UNITED STATES
DEPARTMENT OF THE INTERIOR
BUREAU OF LAND MANAGEMENT

SUNDRY NOTICES AND REPORTS ON WELLS
Do not use this form for proposals to drill or to re-enter an abandoned well. Use Form 3160-3 (APD) for such proposals.

7. If Unit of CA/Agreement, Name and/or No.
8. Well Name and No. **Hubbard 2A**

Re: Permanent Abandonment
Well: Hubbard #2A

Proposed Schematic

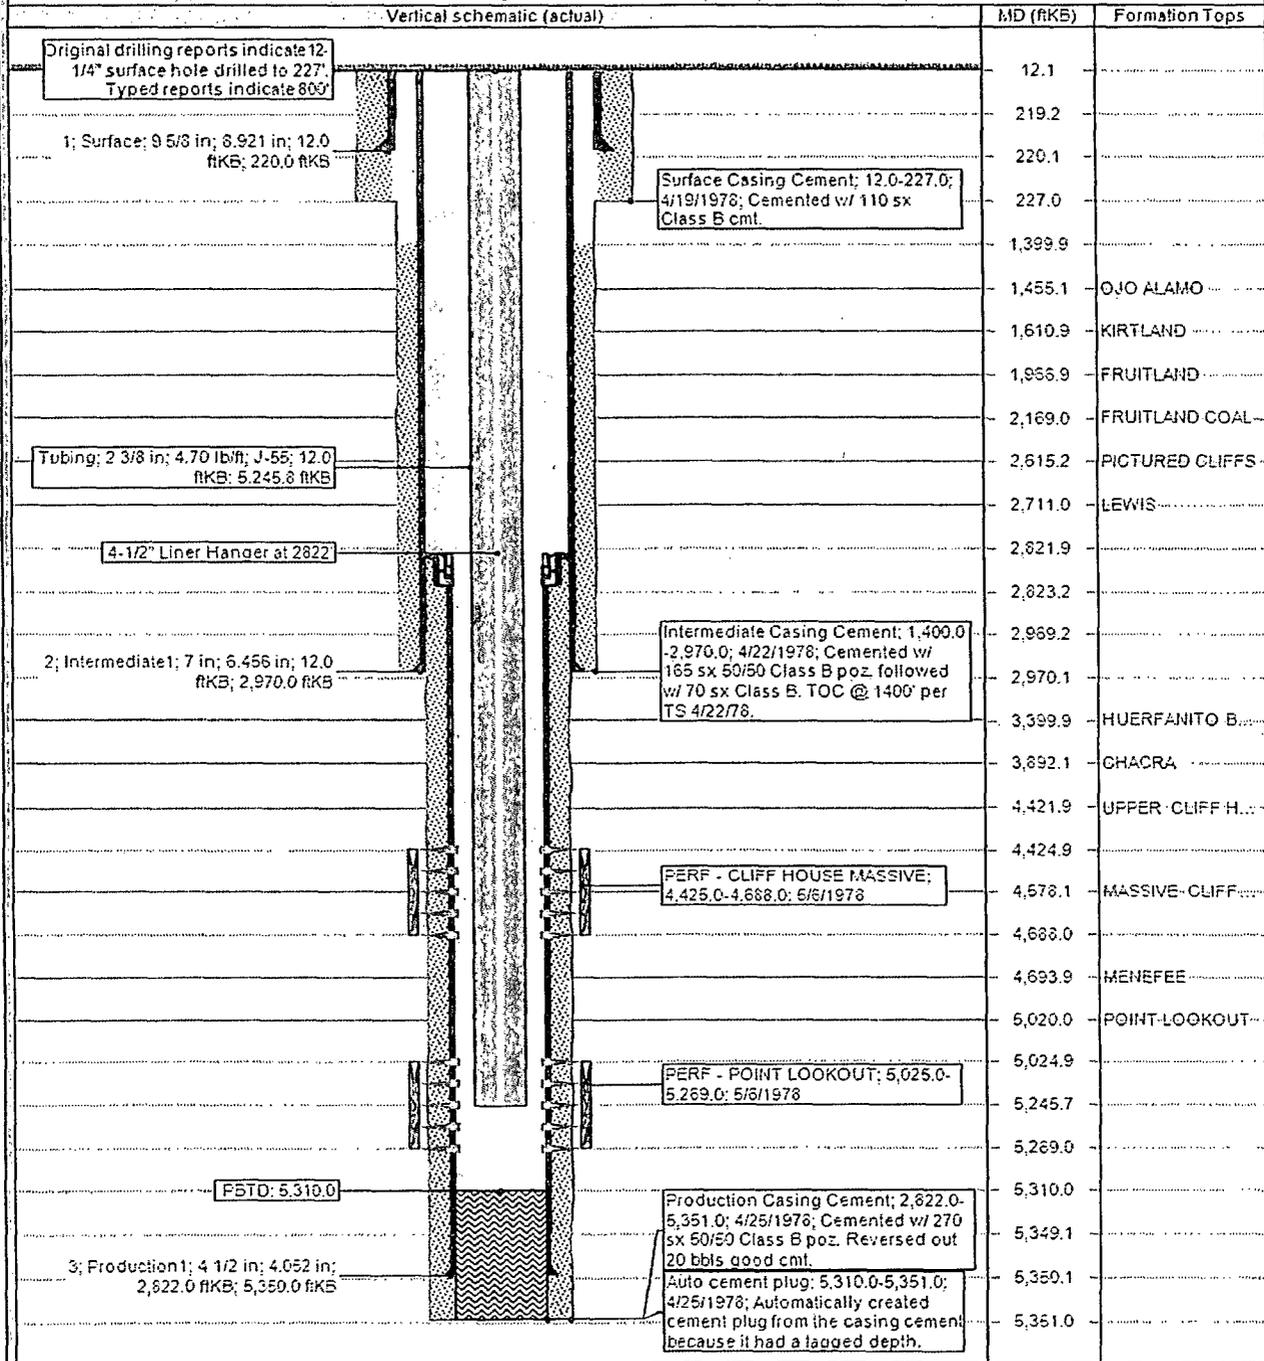
1. Plugging operations authorized are subject to the attached "General Requirements for Permanent Abandonment of Wells on Federal and Indian Lease."
2. Farmington Office is to be notified at least 24 hours before the plugging operations commence (505) 564-7750.
3. The following modifications to your plugging program are to be made:
 - a) Place a plug (3451-3351) ft. to cover the Chacra Equiv. (Huerfanito Bentonite) top.
 - b) Place plug #3 (2237-2137) ft. to cover the Fruitland top.
 - c) Place plug #4 (1055-955) ft. to cover the Kirtland top. The Ojo Alamo is not present or recognizable in the area of this well.

Operator will run a CBL to verify cement top. Submit the electronic copy of the log for verification to the following addresses: tsalyers@blm.gov Brandon.Powell@state.nm.us
